1966 Corvette: Service Bulletin: Automatic Choke Malfunction

Subject: Automatic Choke Malfunction

Bulletin No: TSB #66-6, DR #66-6

Date: November 18, 1965

FIG. I - CHOKE THERMOSTAT ASSEMBLY - 283 V-8

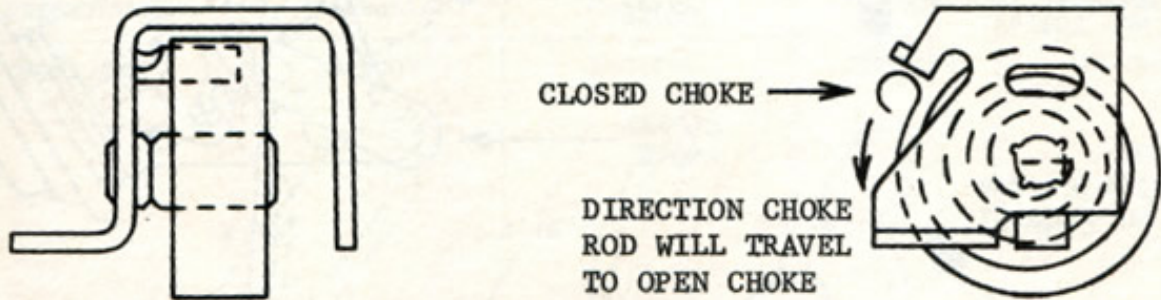
NOTE: Choke thermostat assemblies, although similar in appearance, are not interchangeable. Check bracket design as shown in Figures I, II and III and the coil spring identification number shown on chart (Number stamped in coil, not number in ink). Choke coil springs are indexed to bracket and must not be interchanged or repositioned.

FIG. II - CHOKE THERMOSTAT ASSEMBLY - 327 V-8 (275 HP)

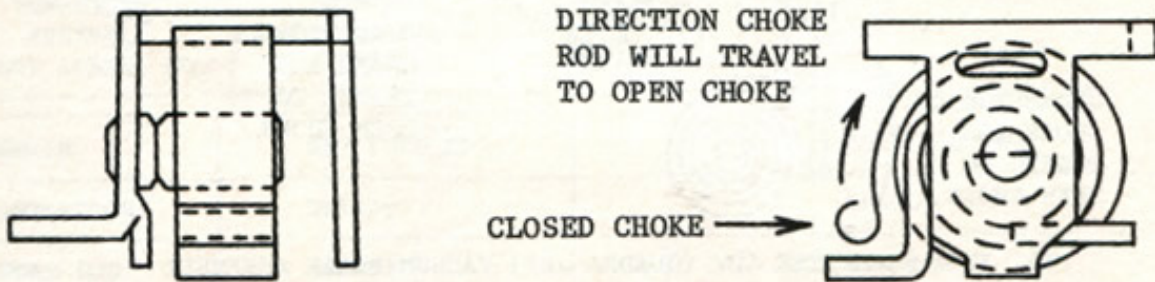
It should be noted that an important difference exists between the 327" (275 h.p.) engine choke operation and the remaining V-8 engines. That is, the direction of the thermostat operation between the two units is reversed. On the 327" (275 h.p.) application, the eye of the thermostat coil and the corresponding choke rod travels from a down position for closed choke relaxing upward for open choke. On the remaining V-8 engines (except 283 4

FIG. IV - ROCHESTER 4MV (QUADRA JET) VACUUM BREAK ASSEMBLY

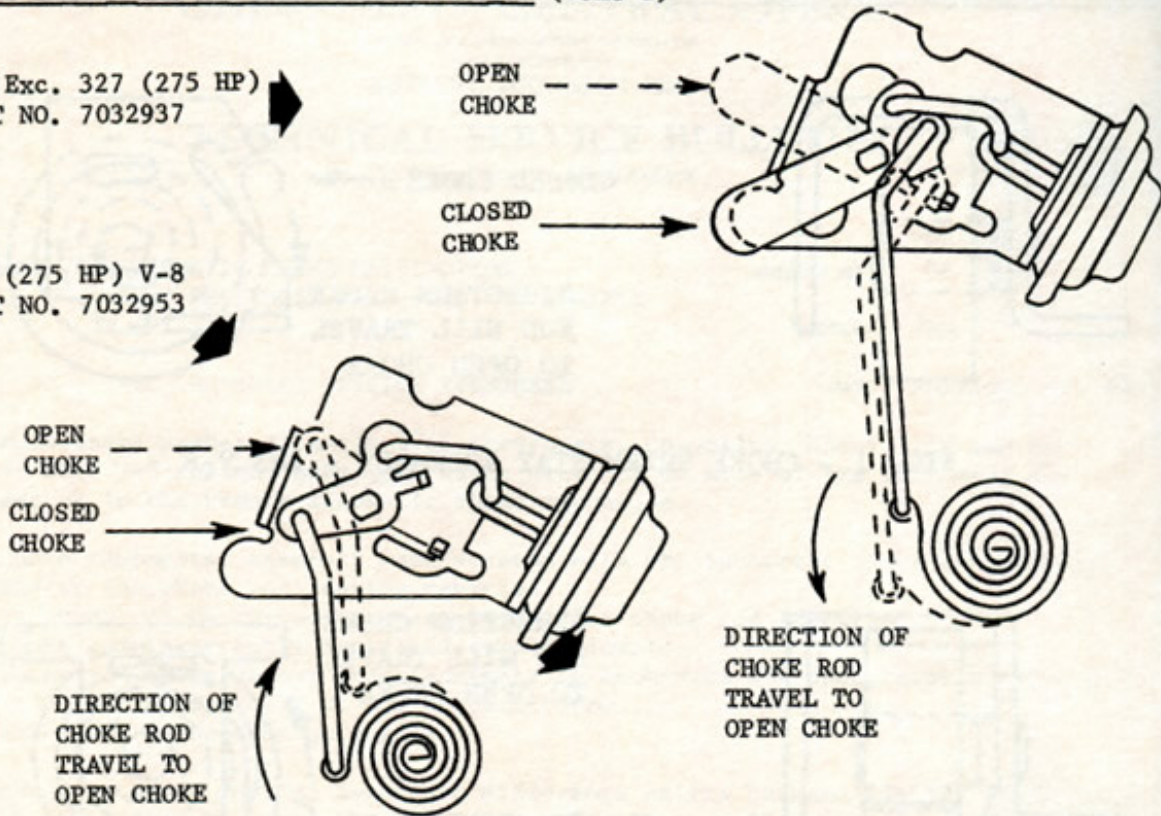
1. Choke thermostat assembly manufactured with the incorrect choke coil spring and/or the choke coil spring reversed.
2. Incorrect choke thermostat assembly and/or choke rod installed.
3. Choke rod incorrectly installed (upside down).
4. Incorrect choke vacuum break assembly on Rochester 4MV carburetor (Quadrajete).
5. Incorrect choke lever on Holley carburetor.
6. Incorrect carburetor on engine.

ROCHESTER 4MV (QUADRAJET) VACUUM BREAK ASSEMBLY REPLACEMENT

1. Remove carburetor air horn as outlined on Page 6M-25 of the 1966 Chassis Overhaul Manual.
2. Remove retaining screw from choke vacuum break assembly, then remove assembly.
3. Remove choke lever from float bowl well.
4. Install choke vacuum break assembly as outlined on Page 6M-27, Steps 5, 6, and 7 of the 1966 Chassis Overhaul Manual.
5. Install carburetor air horn as outlined on Page 6M-29 of the 1966 Chassis Overhaul Manual.
